Waihi Beach – Glen Isla Protection Society Peer Review

NuWave Coastal have been engaged to provide a peer review of the proposed coastal protection works at Glen Isla Place, Waihi Beach. The review is limited to the coastal process and engineering aspects of a proposed rock revetment structure and is required to support a resource consent application submitted to Western Bay of Plenty Council (“WBOP”).

Figure 2: Typical rock revetment cross section provided in the design report.

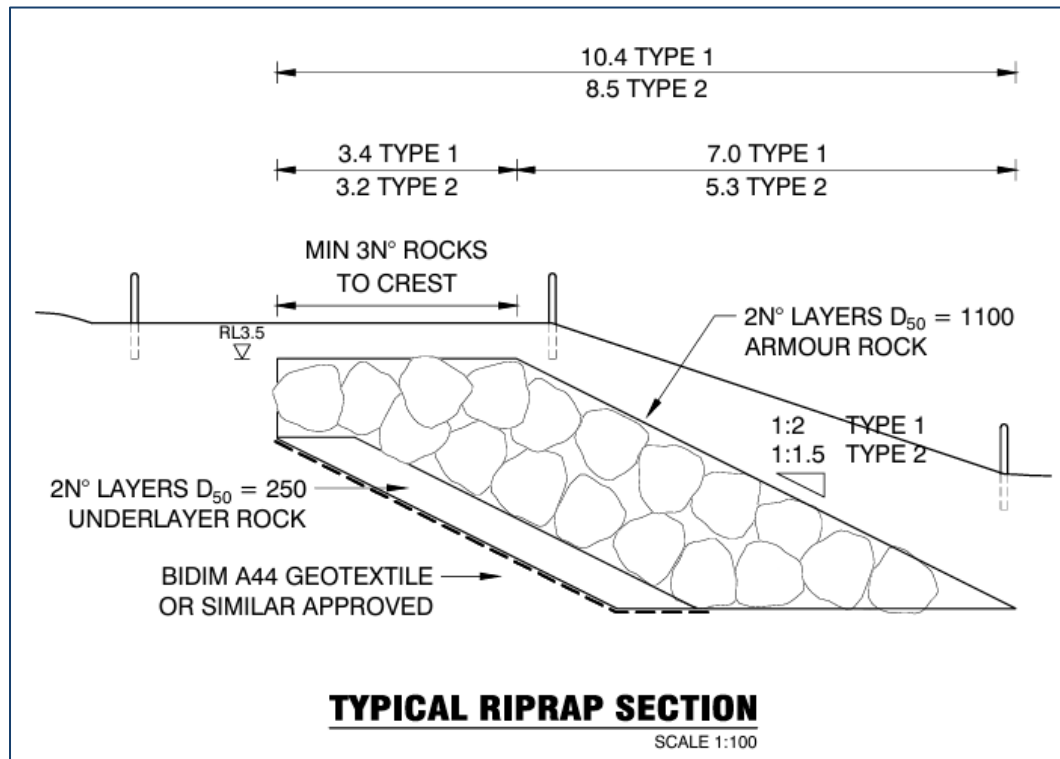
Armour rock – Rock dimensions are appropriate given the design wave climate, however no rock testing information has been provided for the local quarry so there is an assumption that the rock is of a suitable density and complies with the statistical tolerances in the rock manual. It is recommended that testing is carried out prior to construction.

Slope gradient – For the Type 1 wall a 2(H):1(V) slope is considered standard for structures on the open coast. The Type 2 structure has a 1.5(H):1(V) slope, with steeper slopes usually requiring larger rock. However, due to the increased setback of this wall being subject to a relatively smaller wave climate larger rock is not required. In addition the oblique orientation of the wall to the predominant wave direction reduces the required rock size.

Crest width – The crest meets the minimum requirement of 3 rocks wide ($3 \times D_{50}$).

Foundation level – Foundation depth is considered as deep as practical for a sand beach based on the site tide levels. We support the addition of additional rock to form a falling toe if beach levels drop low enough to risk undermining of the toe.

Geotextile – Armour rock is considered semi permeable for overtopping calculations, as drawn the geotextile only comes up to RL 2.0. The consequence of this is likely to be water flowing through the revetment crest when exposed and eroding the dune behind. It is recommended that the geotextile is raised to the crest level of the revetment. It is further recommended to extend the seaward extent of the geotextile to the structure toe.
